Temporary Warehouse (Excluding Dangerous Goods Godown) with Ancillary Office and Public Utility Installation (Solar Photovoltaic System) and Associated Filling of Land for a Period of 3 Years in "Agriculture" Zone, Lot 177 (Part) in D.D. 110, Kam Tin North, Yuen Long (Application No. A/YL-KTN/1294)

Further Information for Planning Application No. A/YL-KTN/1294

Response-to-Comments

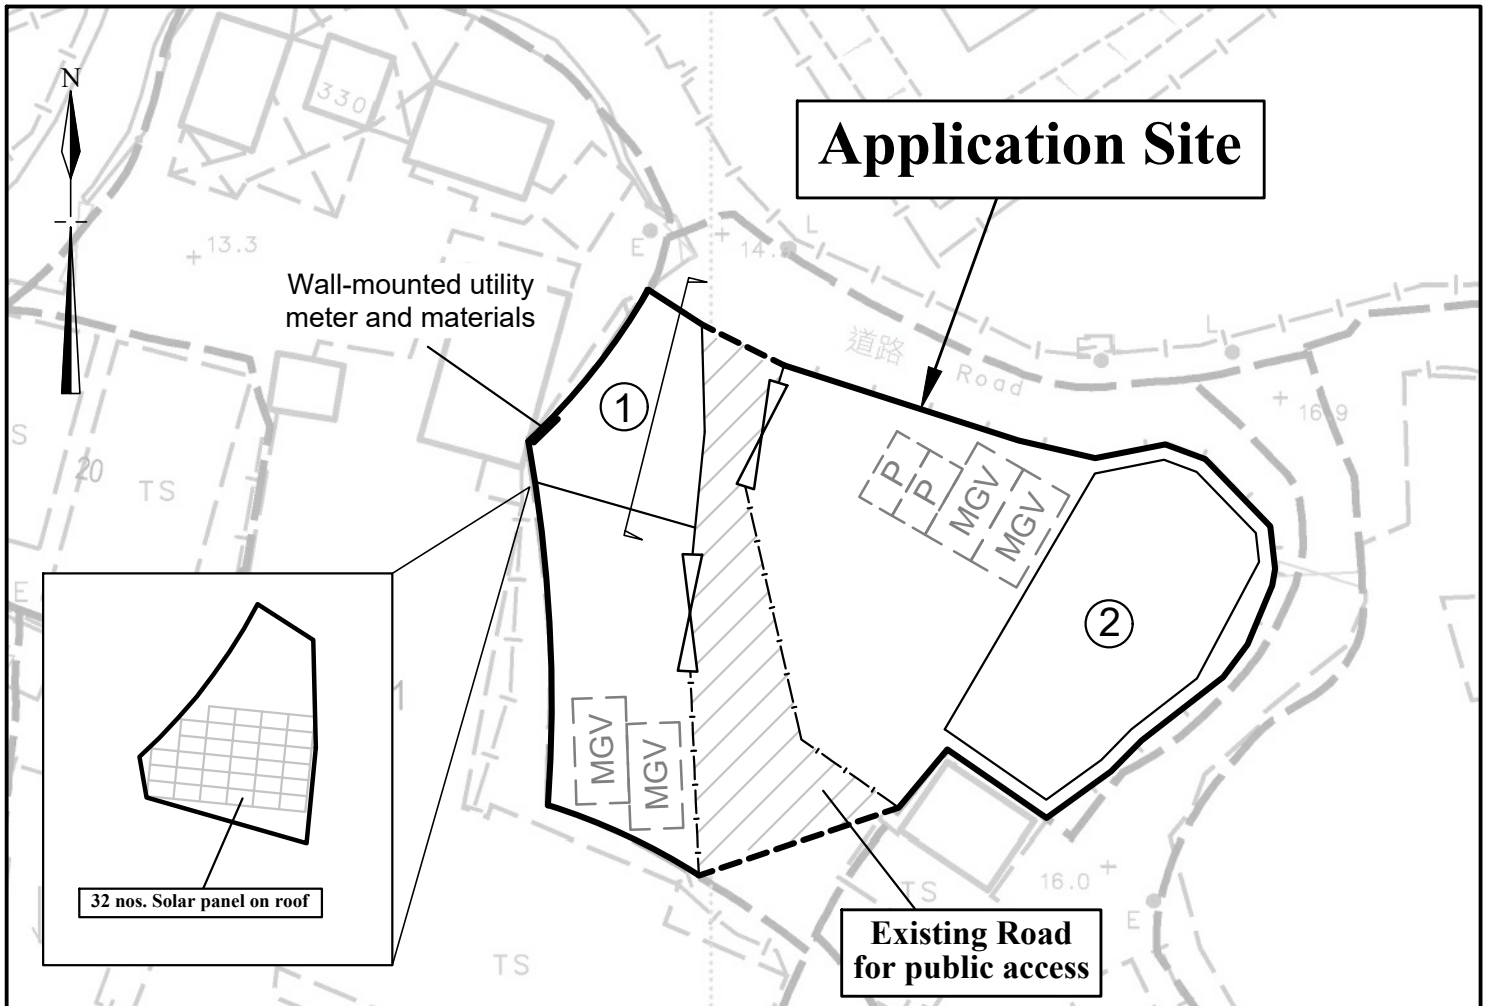
I.	Comments		Responses
1.	Please clarify if the solar panel system has been installed at the Site. If affirmative, please provide photos of the said system;		The solar panel system has been installed at the Site. Site photographs are attached for your information.

1:500	**Layout Plan**	Goldrich Planners & Surveyors Ltd.
November 2026	Lot 177(Part) in DD.110	Plan 3a (P 26054)

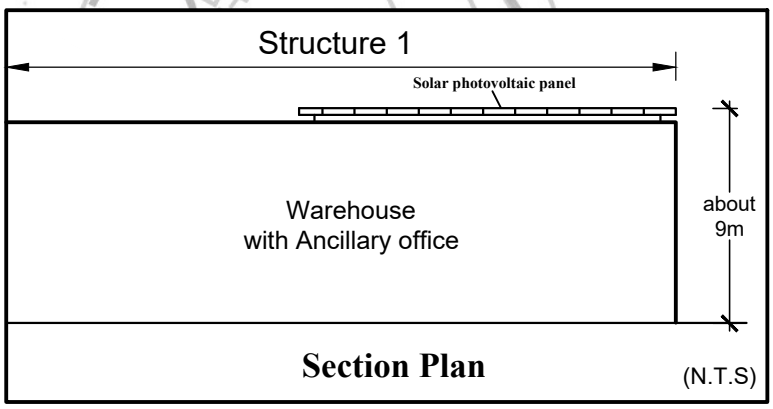
2.	Please provide the details of the solar panel system including but not limited to its dimension (including its height), the location(s) of the utility/electricity meter/distribution board/inverter and materials;		The dimensions of the solar panel, including the height of the metal mounting frame on the rooftop are about 1,060mm (W) x 1,760mm (L) x 90mm(H) each. The utility/electricity meter/distribution board/inverter and materials are installed on internal wall of structure 1. Please see the updated layout plan (Plan 3a) for details.

4.	Please provide the section plan for structure 1.		Please see the updated layout plan (Plan 3a) for the section plan.

Peripheral metal fencing of about 2.5m in height, excluding the ingress/egress of the public access road, has been erected along the site boundary to minimise the potential nuisance to the surrounding area. Fencing has also been erected along the two sides of the public access road as indicated in the layout plan.
